# Access Compliance Report

## Public Rights-of-Way

### (Curb Ramps)

Intersection ID: 25305	Main Street: MATTIA_CT	Cross Street: MAYNARD_RD	Location: W
ADA ID: 4824E792E03F	Ramp Type: Directional1	Initial Pass/Fail: Fail	Overall Compliance: No
Severity Score: 1.25			
Codes/Mitigation Info/Possible Solution		Field Measurements/Component Compliance

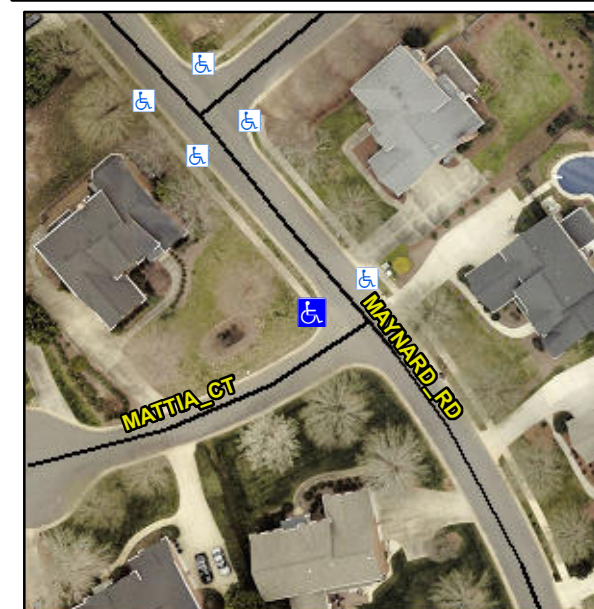
**Remove & Replace Entire Ramp.**

**R304.5.3**

Compliance	Description	Data	Compliance	Description	Data
N/A	Ramp Length (in)	65.0	N/A	Grade Break?	N/A
Yes	Ramp Width (in)	49.0	N/A	Grade Break Slope (%)	0.0
Yes	Ramp Slope (%)	3.8	N/A	Grade Break XSlope (%)	0.0
No	Ramp XSlope (%)	4.3			
N/A	Flare Type LT	N/A	N/A	Flare Type RT	N/A
N/A	Flare Slope LT (%)	N/A	N/A	Flare Slope RT (%)	0.0
N/A	Flare Traversable LT?	N/A	N/A	Flare Traversable RT?	N/A
N/A	Landing Length (in)	0.0	N/A	DWS Provided?	N/A
N/A	Landing Width (in)	0.0	N/A	DWS Contrast?	N/A
N/A	Landing Slope (%)	0.0	N/A	DWS Length (in)	N/A
N/A	Landing X Slope (%)	0.0	N/A	DWS Full Width?	N/A
N/A	Landing Curb? (Y/N)	N/A	N/A	DWS Offset LT (in)	N/A
N/A	Shared Landing?	N/A	N/A	DWS Offset RT (in)	N/A
N/A	Gutter Ponding?	0.0	N/A	Gutter Slope (%)	N/A
N/A	Gutter Lip Ht (in)	0.0	N/A	Gutter X Slope (%)	N/A
N/A	Painted X Walk1?	No		Road Slope (%)	1.6
	X Walk 1 Direction	To SE		Road X Slope (%)	0.9
	X Walk 1 Width (in)	N/A		Clear Space?	N/A
